CONSTRUCTION PLANS FOR CREEKSIDE AT LORSON RANCH FILING NO. 1 STREET AND STORM SEWER CONSTRUCTION PLANS

Engineering Review

PUDSP-18-005
SF-19-00X

**CREEKSIDE AT LORSON RANCH FIL NO. 1
STREET / STORM SEWER
CONSTRUCTION PLANS**

CORE ENGINEERING GROUP
15004 1ST AVENUE, S.
DENVER, CO 80202
PHONE: 719.570.1100
CONTACT: RICHARD L. SCHINDLER, P.E.
EMAIL: Rich@ceg1.com

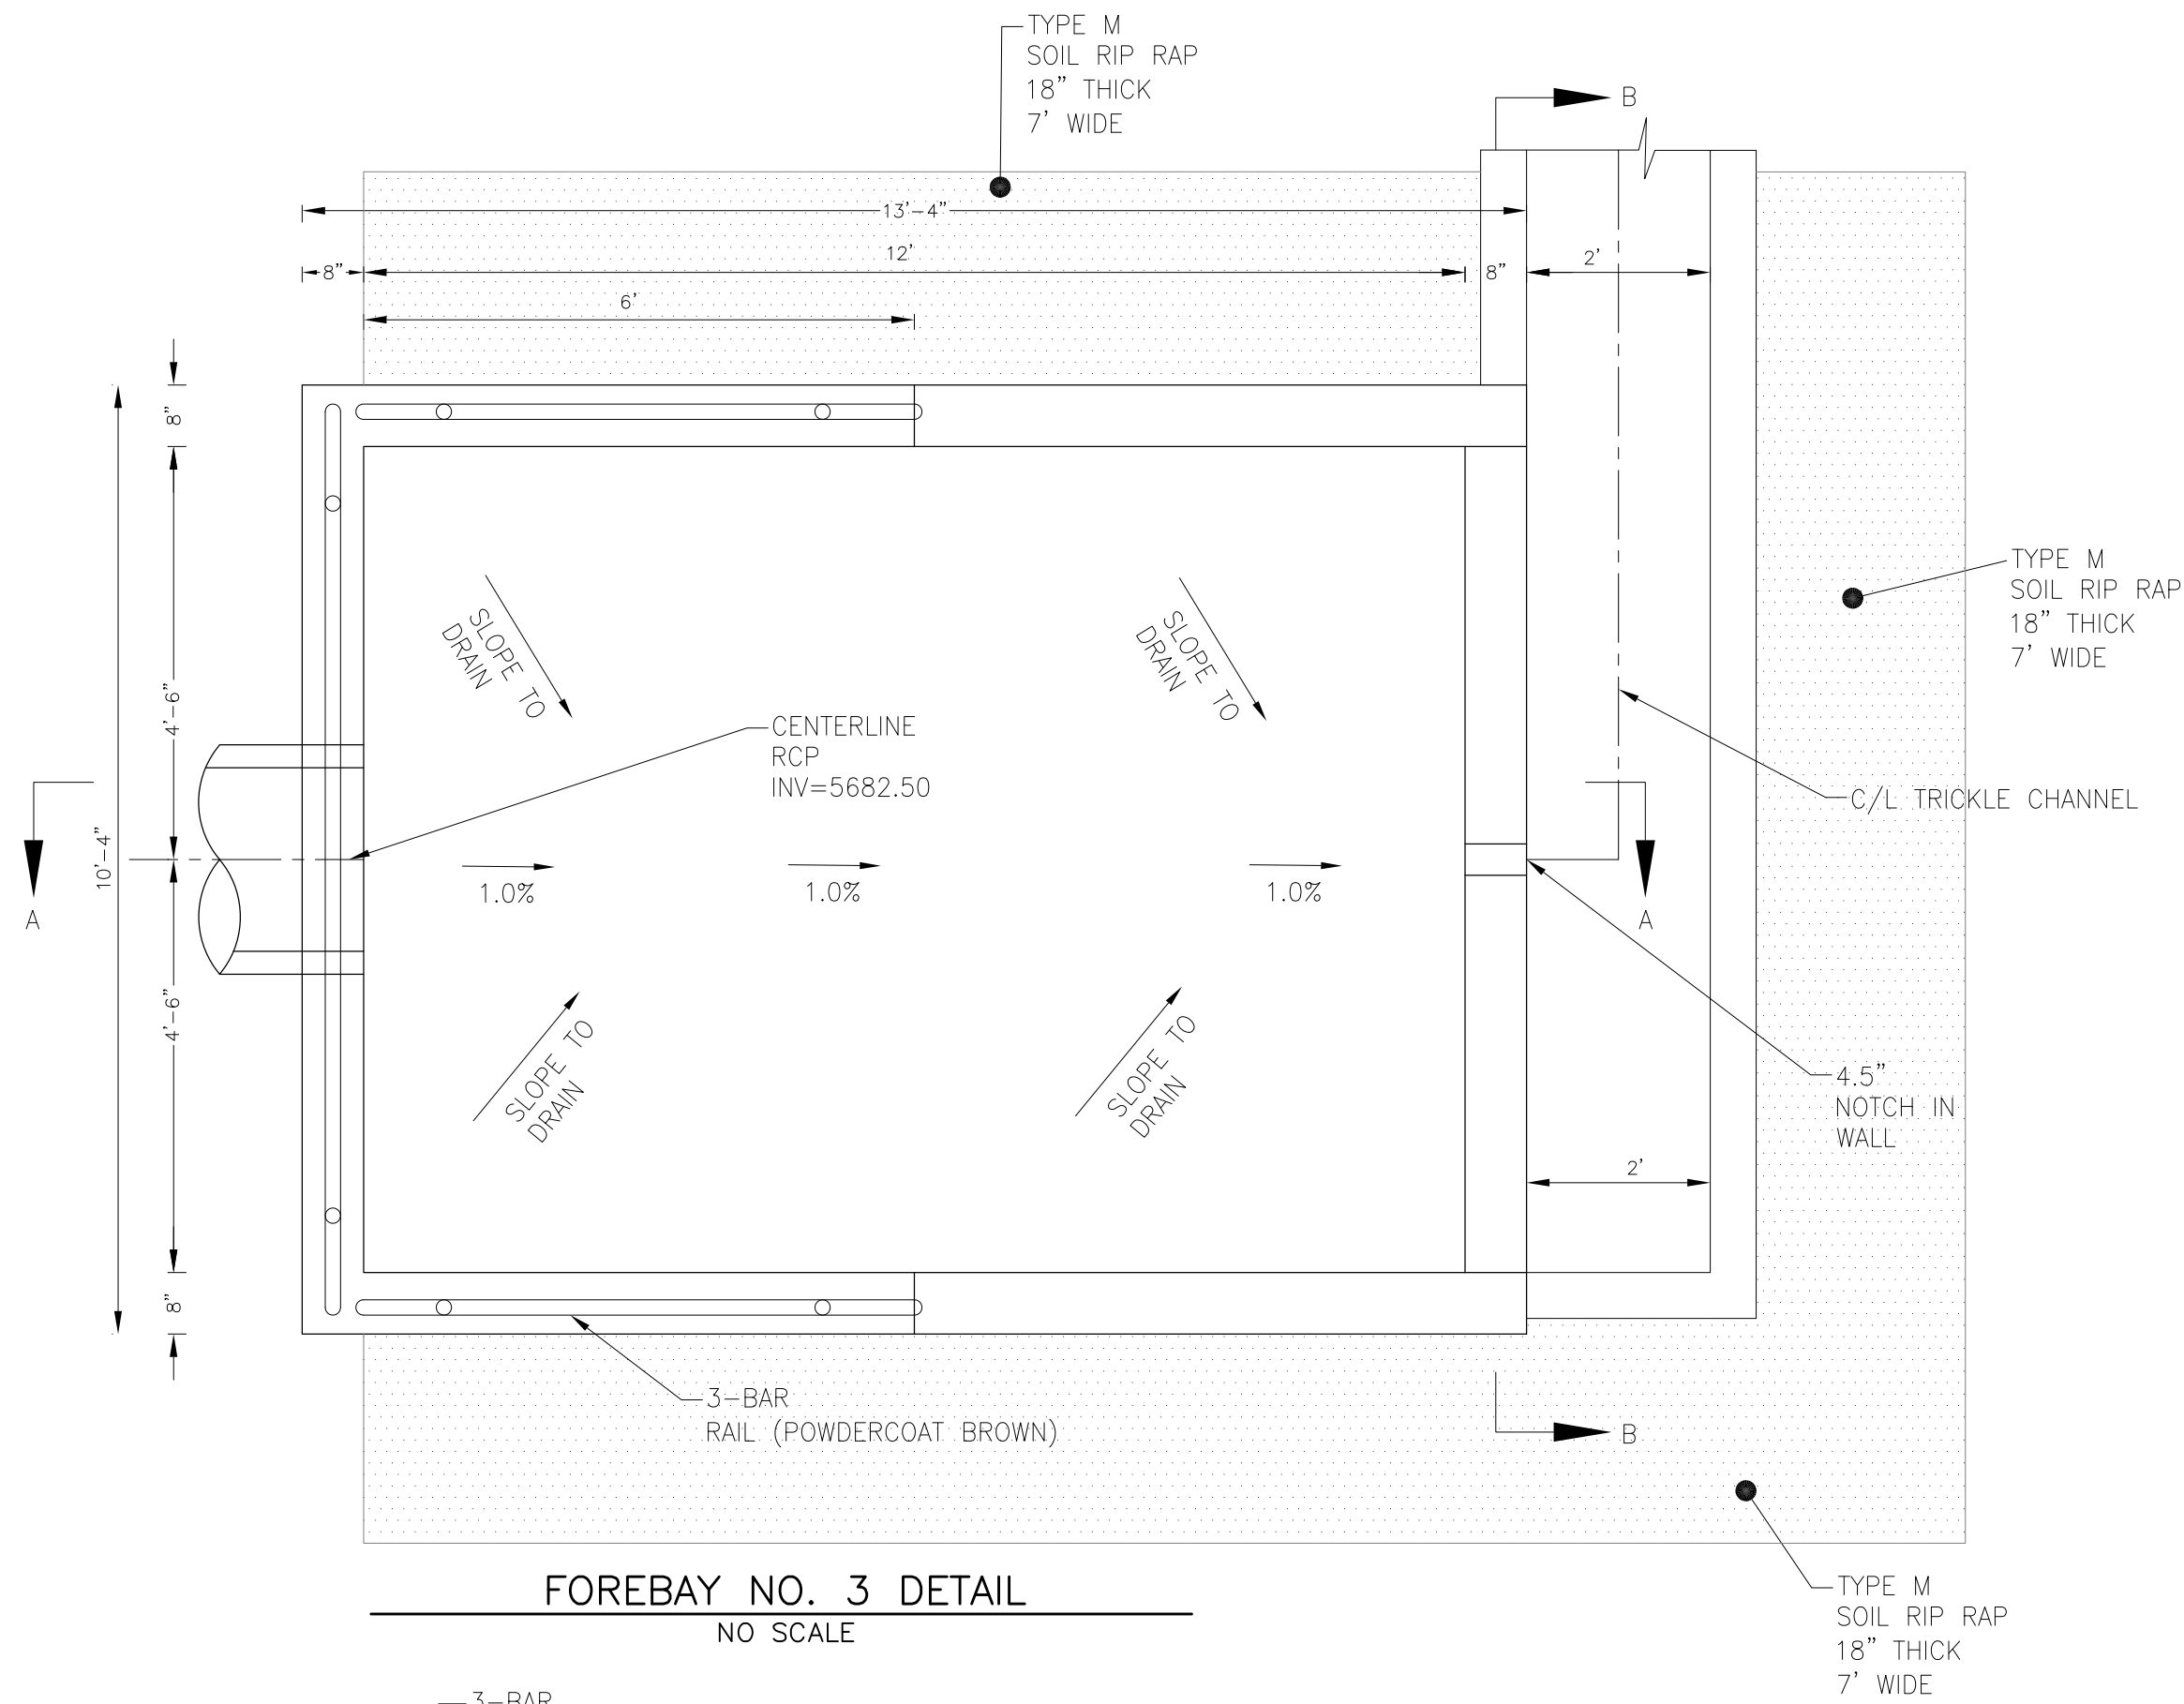
Isn't 2A the reverse/reflection of 2B?
